PD Modification Application:

PRS 22-1144

Hillsborough
County Florida

Request: Minor Modification to PD

Option 3: Site Plan, Received 8-4-22

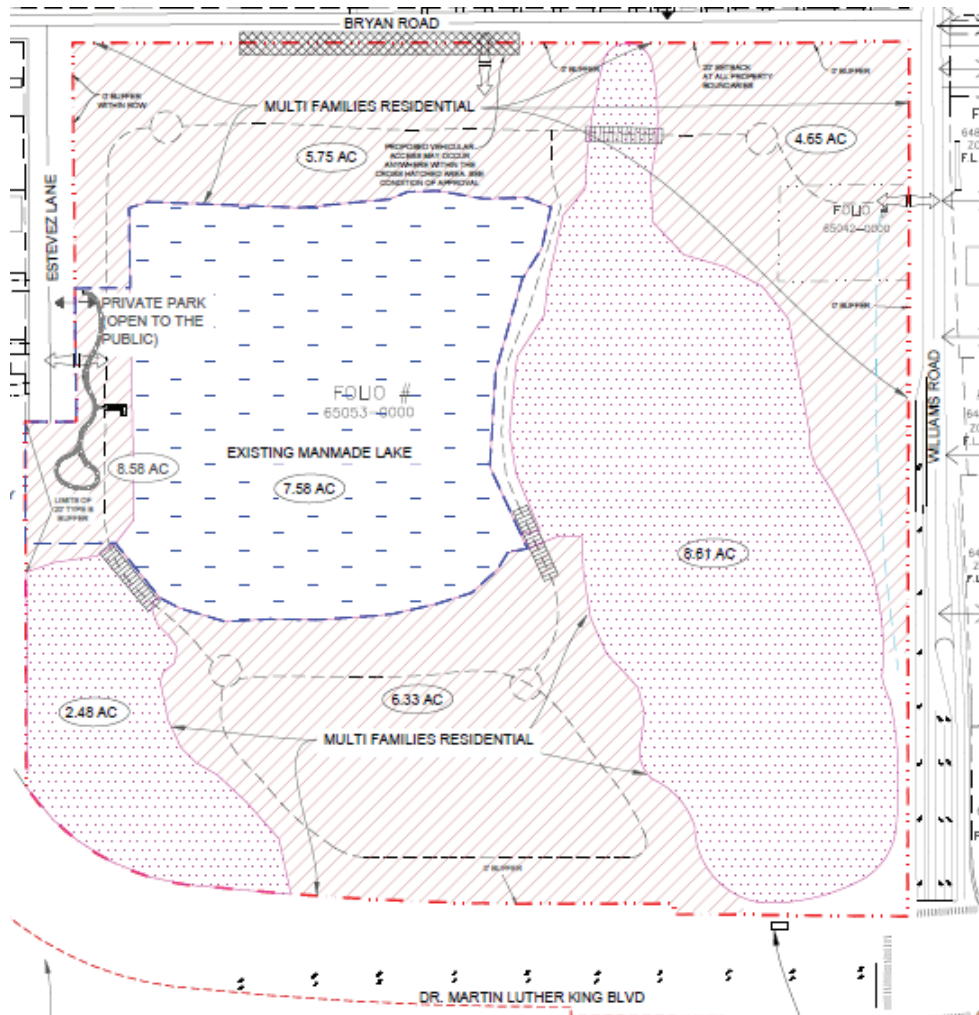
Prior to PD Site Plan Certification, the developer shall revise the PD site plan to:

- Revise Note 7 to state, “The proposed multi-family units may be constructed in multiple phases; however, the park use shall be constructed concurrent with the initial phase (see conditions of approval). Additionally, all vehicular and pedestrian access connections as well as external sidewalks shall be constructed within the first phase.”

- Revise Note 9 to add “however, a publicly accessible private park is included. See conditions of approval.”
- Remove Note 11 and renumber all remaining notes.

- Revise Note 21 to add “Subject to Restrictions Outlined within the Conditions of Approval” at the end of the first sentence.
- Revise Note 27 to fully describe existing sidewalk conditions along all roadways fronting the project, or otherwise remove the note.

- Revise Note 28 to fully describe existing bicycle facilities along all roadways fronting the project, or otherwise remove the note.
- Revise Note 30 to delete everything after and including “As such.” Replace language with a note reading “See conditions of approval for language governing required easements and other design considerations.”

- Delete Note 31.

Staff notes that the PD site plan does not depict a parking area on the site plan. As noted above, the applicant will be required to go through a process to determine the amount of parking required to serve the park use.
